Subject: Response to U.S. EPR Design Certification Application RAI No. 492 (5815),
FSAR Ch. 9, Supplement 8
Sent Date: 8/15/2012 7:49:10 AM
Received Date: 8/15/2012 7:49:34 AM
From: WILLIFORD Dennis (AREVA)

Request for Additional Information No. 492(5815), Supplement 8

U.S. EPR Standard Design Certification

**SRP Section: 09.03.04 - Chemical and Volume Control System (PWR) (Including
Boron Recovery System)**

Figure 09.03.04-23-1–Ammonia, Hydrogen and Total Gas in PWR Reactor Coolant

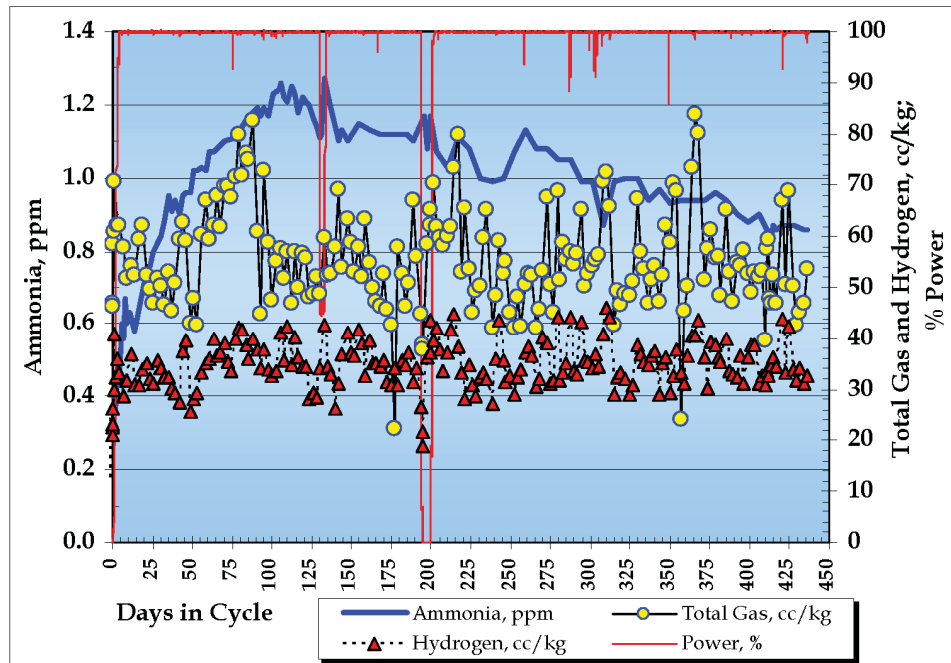
Question 09.03.04-23:

RAI 200, Question 09.03.04-19 Part 3 indicated that the equilibrium concentration of ammonia and its effect on demineralizer performance are to be provided at a future date (later in the design process)

Therefore, the Staff requests the applicant to describe the effect of ammonia build on the RCS demineralizer performance.

The ammonia in the coolant is limited by radiolysis reactions, the nitrogen level in the coolant, boron dilution and ion exchange. The pressurizer vapor space is continuously vented, which provides another means to limit nitrogen and ammonia. Ammonia is typically about 1 ppm in PWR reactor coolant, as shown in Figure 09.03.04-23-1, for a plant that measures hydrogen and total gas. The difference between the total gas and hydrogen is attributed mostly to nitrogen, with helium from boron-10 activation in the coolant (re: $^{10}\text{B}(n,\alpha)^7\text{Li}$ and $^{10}\text{B}(n,2\alpha)^3\text{H}$) and trace noble gas comprising the remainder. As shown in Figure 09.03.04-23-1, based on the difference between the total gas and hydrogen concentrations, a typical U.S. PWR has dissolved nitrogen levels similar to or slightly greater than the German KONVOI plants, which use a gas management scheme similar to that used in the U.S. EPR plant.

As shown in Figure 09.03.04-23-1, the expected concentration of nitrogen (6-8 cc/kg) in the U.S. EPR reactor coolant is not expected to result in excessive ammonia levels in the reactor coolant. In addition, the pH calculation programs available to U.S. utilities, such as the EPRI Primary pH Calculator, include ammonia in the pH calculation, allowing coolant pH to be accurately predicted and controlled in the presence of ammonia. Since lithium is routinely measured and carefully controlled within prescribed limits in the reactor coolant, ammonia at the several-ppm level will not present undue challenges to RCS lithium control for the U.S. EPR plant. This conclusion is verified by Figure 09.03.04-23-2, which shows that lithium was easily controlled with 7.05 ppm ammonia in the coolant during a mid-cycle outage.
